**Statement of Response
to An Bord Pleanála
Opinion**

**Proposed SHD Planning
Application**

**Blackglen Road
Sandyford
Dublin 18**

**On behalf of
Zolbury Ltd.**

Figure 7 – Cross Sections EE and FF

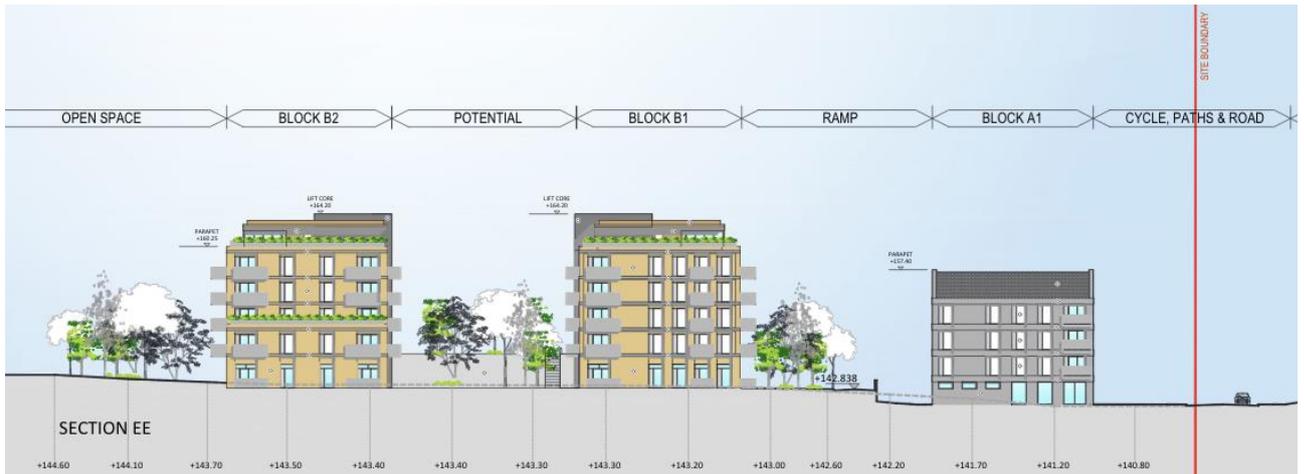
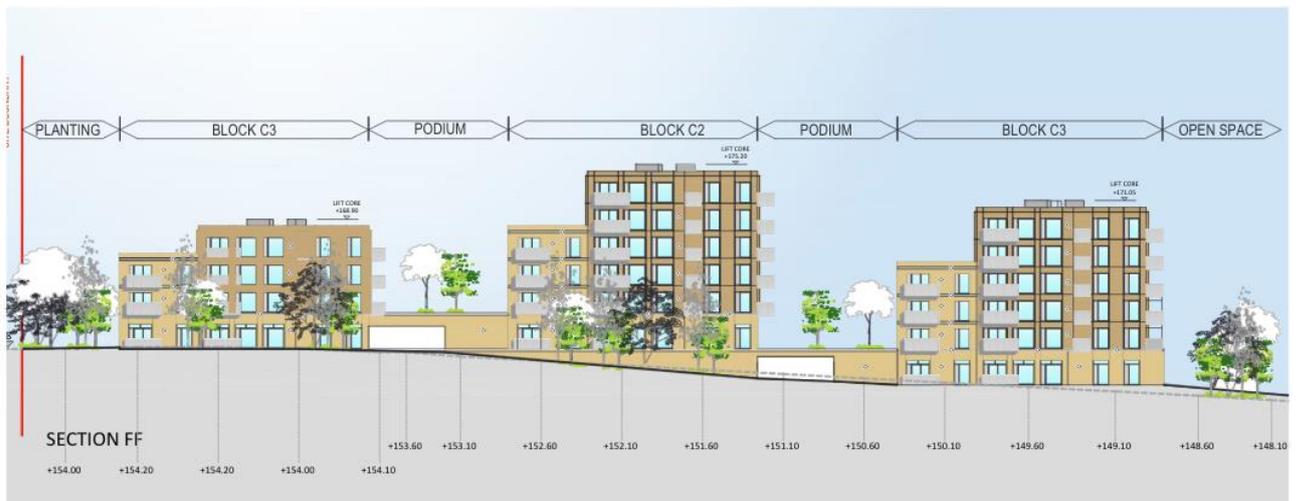
Further justification for increased heights and higher densities at this location, based on the applicable Dun Laoghaire-Rathdown County Development Plan, the perspective applicant should fully address the issue raised by the PA in their opinion, explicitly addressing issues regarding the transitional zone, noting the surrounding established urban context and the potential visual impact, in particular noting the high amenity lands and the foothills of the Dublin Mountains to the southwest.

The scheme demonstrates that a sensitive approach is taken through the integration of buildings with the landscape character. Various performance criteria are used to analyse and test the quality of the scheme in relation to various parameters, all of which demonstrate that the design, building layout, form and heights are well considered and appropriately modulated to ensure that the residential amenity of adjoining properties are protected and are not adversely impacted by this proposed development. Furthermore, there is no resulting negative visual impact from the proposals as referenced in the LVIA report.

The adjusted scheme design takes account of the comments received at the Tripartite stage meeting and the resultant reduction in height, scale and massing to specific sensitive views particularly along Woodside Road to the Southwest and Slate Cabin Lane to the Southeast, illustrate the improvements and the very slight to moderate impact these buildings will have on the surrounding receiving environment.

Figure 9 - Map showing public transport

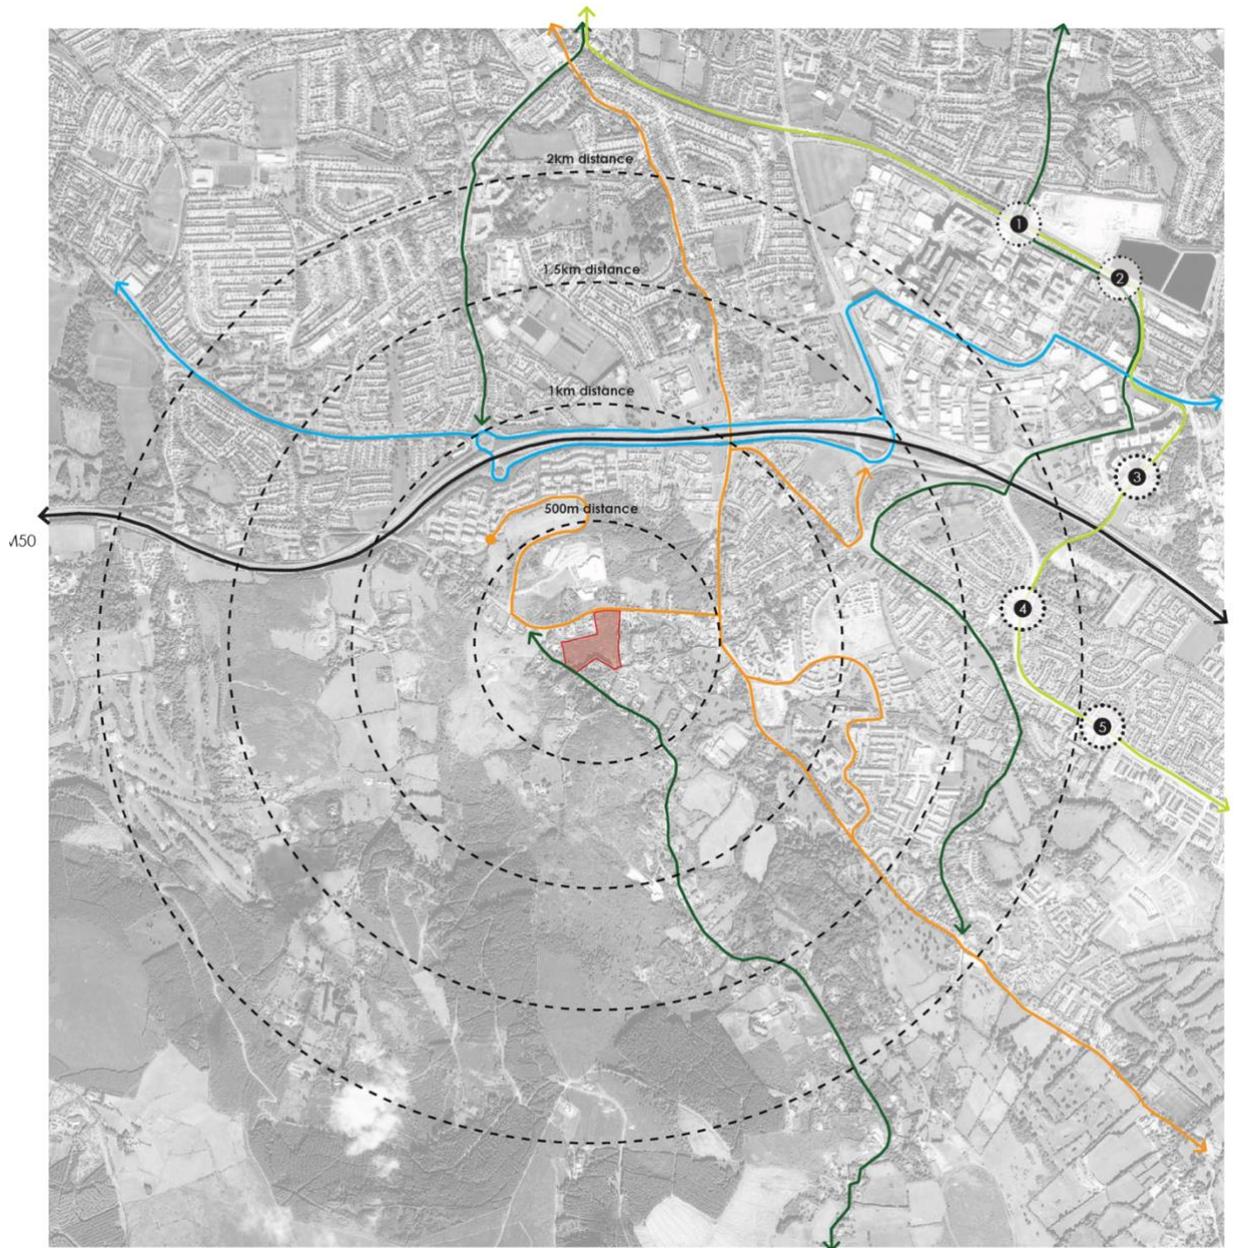
Further justification for increased heights and higher densities at this location, based on connectivity, capacity, and frequency of public transport and specifically consideration and compliance with Section 3.2 of the Urban Development and Building Height Guidelines 2018. SPPR3 of the Urban Development sets out, inter alia, that in the event of making a planning application, the applicant shall demonstrate that at the scale of the relevant city / town that the site is well served by public transport with high capacity, frequent service, and good links to other modes of public transport. The applicant is requested to have regard to this policy, as well as other relevant policies at a local and national level, as may be applicable to the proposed development.

The site is served by public transport with high capacity, frequent service and good links to other modes of public transport. The Glencairn Luas stop (with park and ride) on the Green line is 1.9km from the proposed site, a 27-minute walk or 9 minute cycle from the site entrance. The LUAS provides frequent high capacity services to and from the City Centre. There are bus stops on Blackglen Road and Lamb’s Cross which provide good connectivity to the surrounding area and other modes of public transport. The 44b Bus route at Lambs Cross which connects to Dundrum Luas Station and the 114 Bus, which runs to Blackrock DART station.

These modes of transport provide direct connections through the city region, including the city centre, where residents can easily transfer to other routes and modes for onward connectivity.

Figure 13 – Separation distances to the north

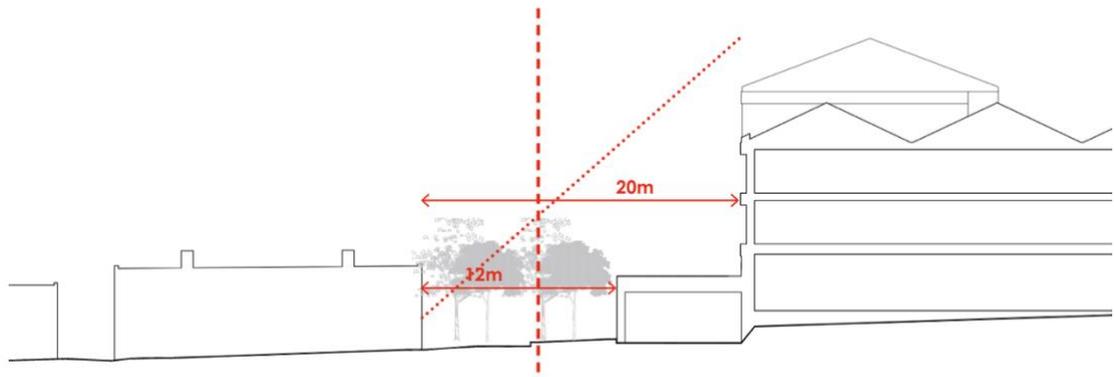
The following section explain the sectional relationships and stepping down towards the boundaries relative to the separation distances to the existing residential neighbouring properties. These have been used throughout the design process in order to reduce the impact of the proposal on adjacent neighbouring properties.

The separation distances between the proposed development and the surrounding Blackglen Road properties to the North are 12m at a podium level and 20m between adjacent residential windows. In addition to the considerable setback distance provided along the North Eastern boundary, the visual impact from Blackglen Road is diminished further by the presence of the existing tree belt which provides a continuous 'green veil' along the East, South and Western boundaries to the site.
